1.1.1 Supplementary Report – Planning Proposal ‘Burrundulla’, Lots 3 & 4 DP1069441 Spring Flat Road, Mudgee

REPORT BY THE TOWN PLANNER TO 17 JUNE 2015 COUNCIL MEETING
Supplementary Report – Planning Proposal Spring Flat Road
GOV400043, LAN900043, LAN900044

Figure 2- Indicative area to accommodate 25 lots

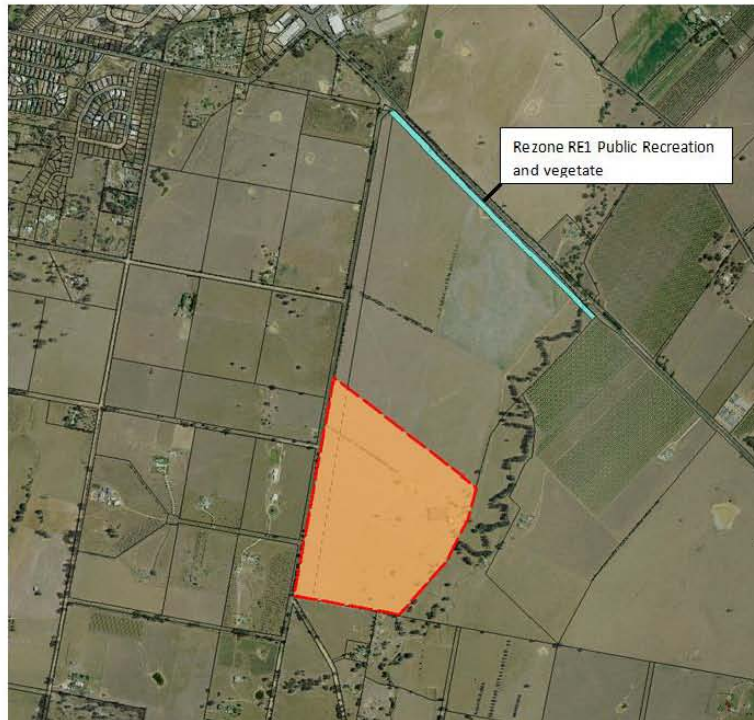
In light of this, it is recommended that the Planning Proposal be amended to rezone only the southern portion of the site R5 Large Lot Residential with a minimum lot size of 2ha to accommodate the 25 lots. The southern portion of the site is considered most suitable for rural residential development as it is setback approximately 1 kilometre from Sydney Road and is enclosed by a mature vegetation screen, providing an ample visual buffer to protect the main entrance corridor to the Mudgee town centre. An indicative location is identified in Figure 2 below.

2. Council support in principle the intent of the Planning Proposal for 2ha rural residential lots on the subject land with an additional requirement that the documentation be amended:

- i) such that the land that is rezoned is limited to an area sufficient to accommodate 25 lots at the southern portion of the site; and
 - ii) to rezone a 20m wide corridor along Sydney Road to RE1 Public Recreation and vegetated to act as a visual buffer.
